Change Order Request

PFAS Well 15

Field Order 11- Curb at Generator Area

FO#11

SK-4 DRAWING
RESPONSE TO RFI #35

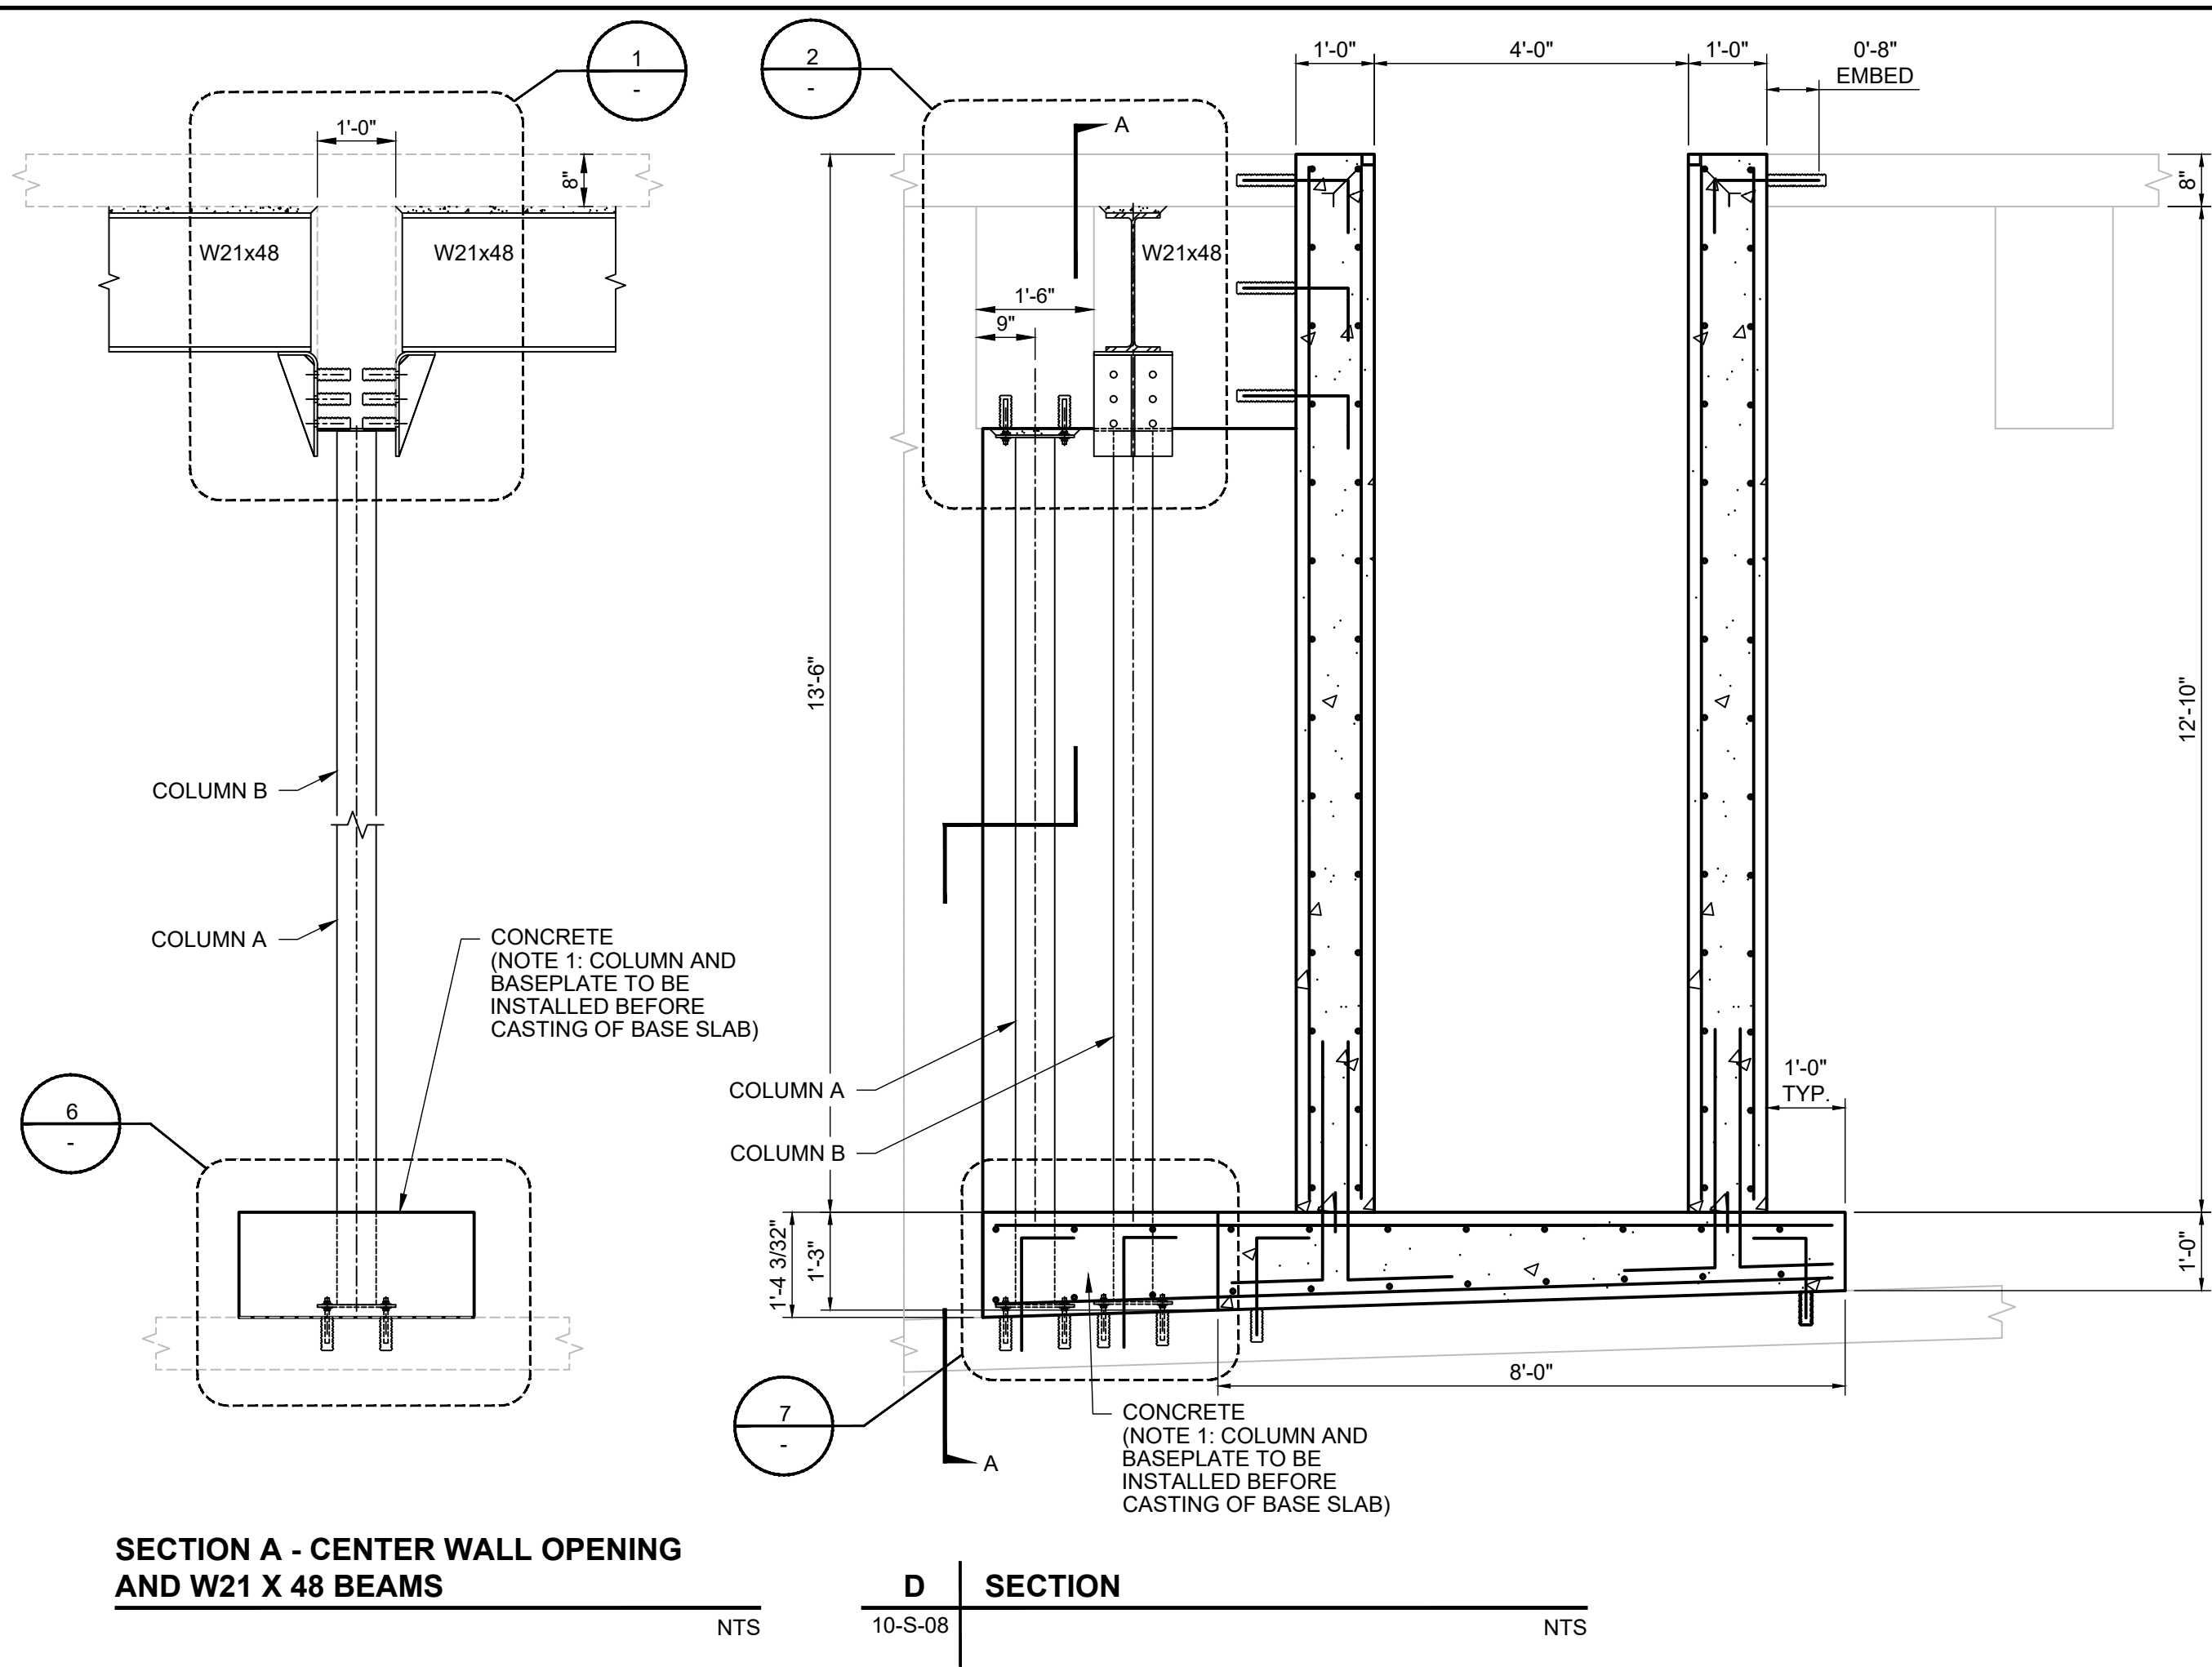
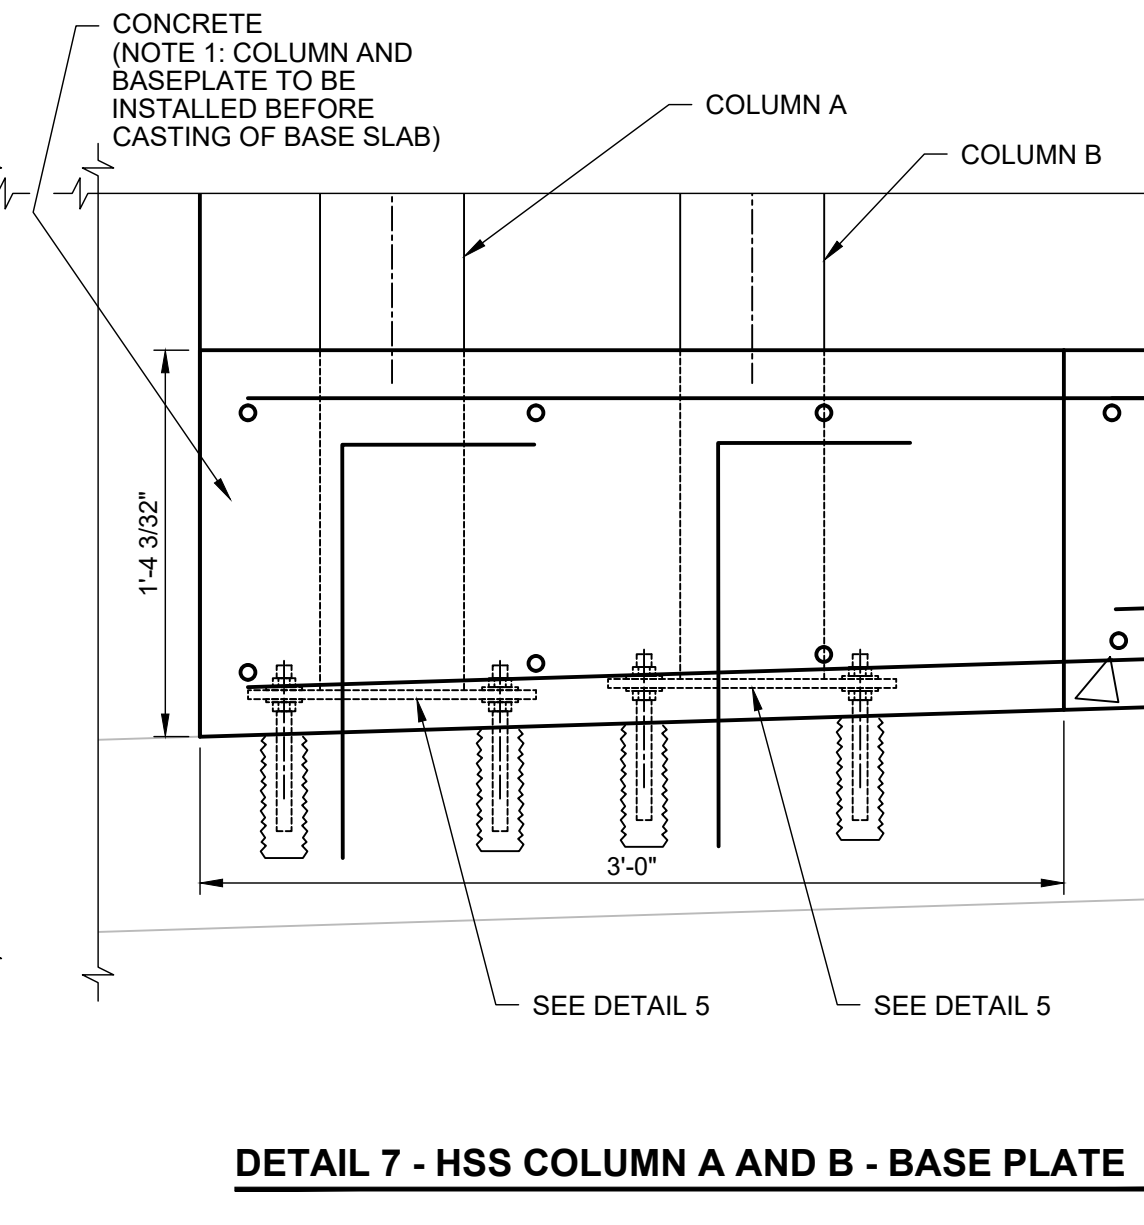
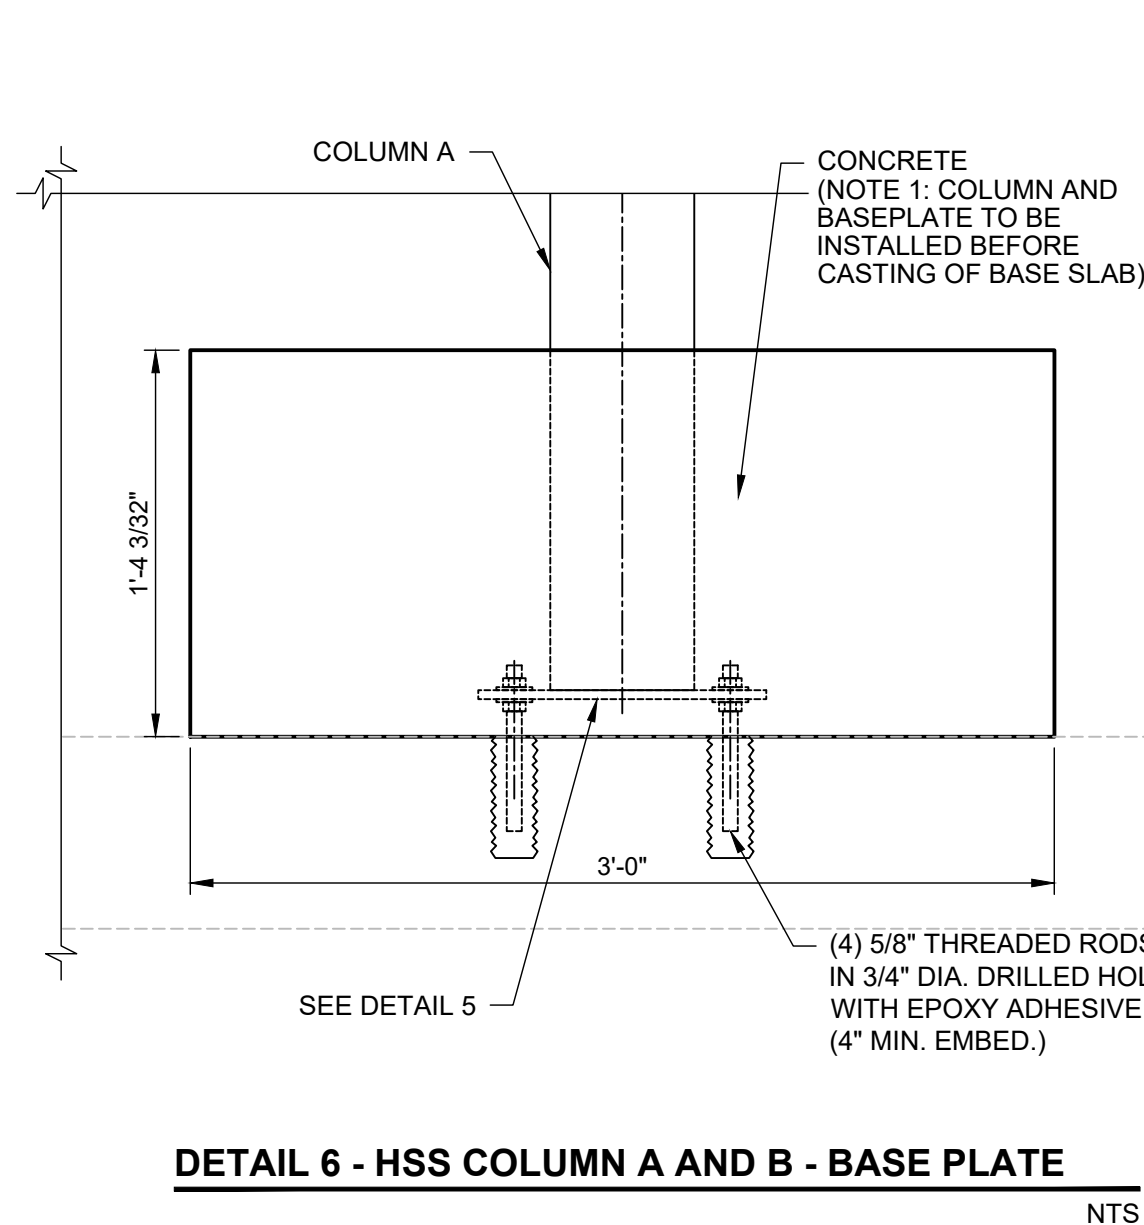
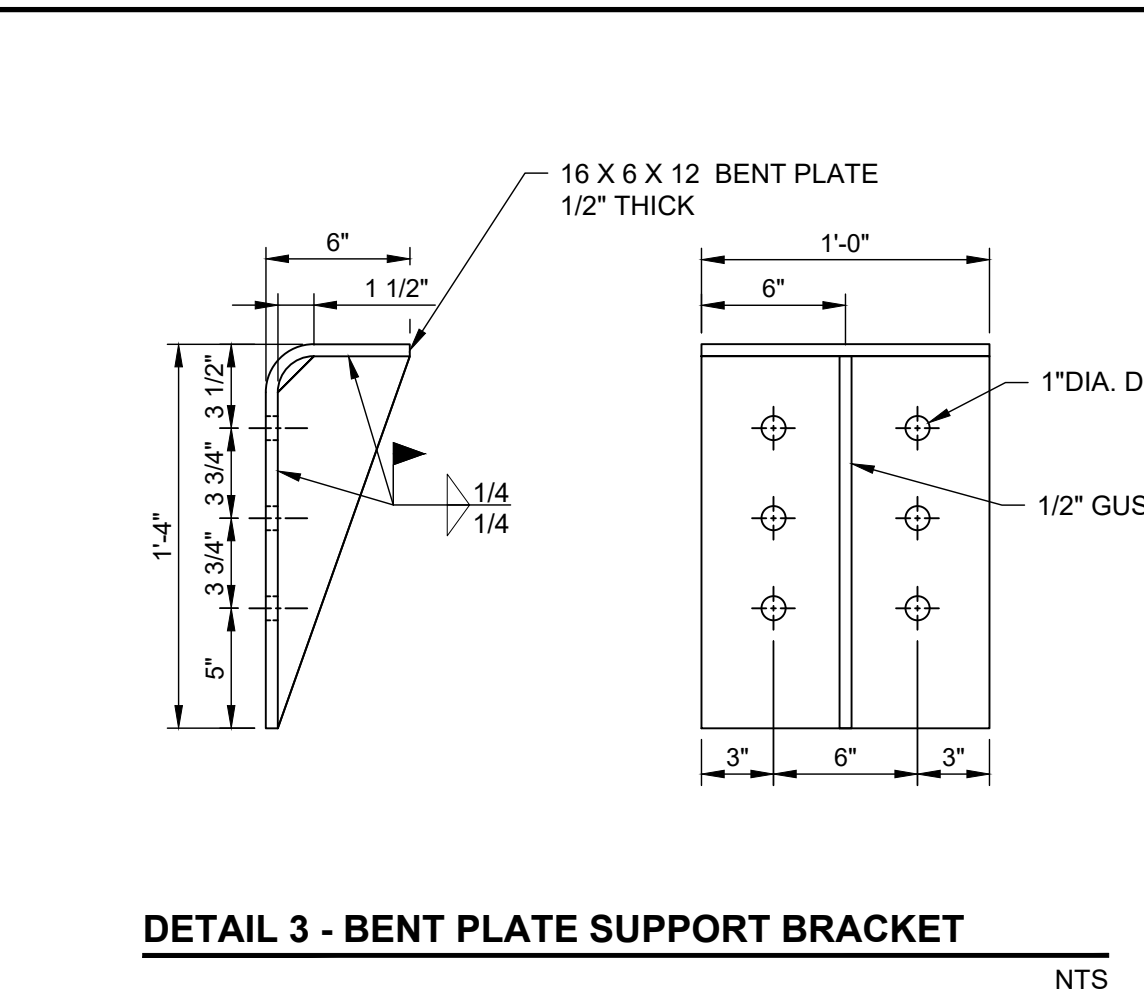
ISSUE/REVISION		
1	10/21/2024	RESPONSE TO RFI #35
I/R	DATE	DESCRIPTION

1. The existing 5 to 6-inch deep sawcuts at the two locations are to be cleaned out and filled with epoxy by gravity feed with resin method in accordance with the manufacturer's recommended installation procedures.
 - a. Reference: American Concrete Institute's' ACI RAP Bulletin 2 – Field Guide to Concrete Repair Application Procedures, Crack Repair by Gravity Feed with Resin.
 - b. Epoxy material shall be Sikadur-32 Hi-Mod manufactured by Sika Corporation or engineer's approved equivalent.
2. Install steel columns as shown on the attached revised drawing Nos. 10-S-01 and 10-S-08, dated 10/21/24 and Sketch SK-4 dated 10/21/2024 to support existing slab and beam floor system. SK-4 will be incorporated into the As-Built drawings when project is completed.
3. Provide cost and schedule impacts, if any, for this work to AECOM and Owner for review prior to commencement of work.
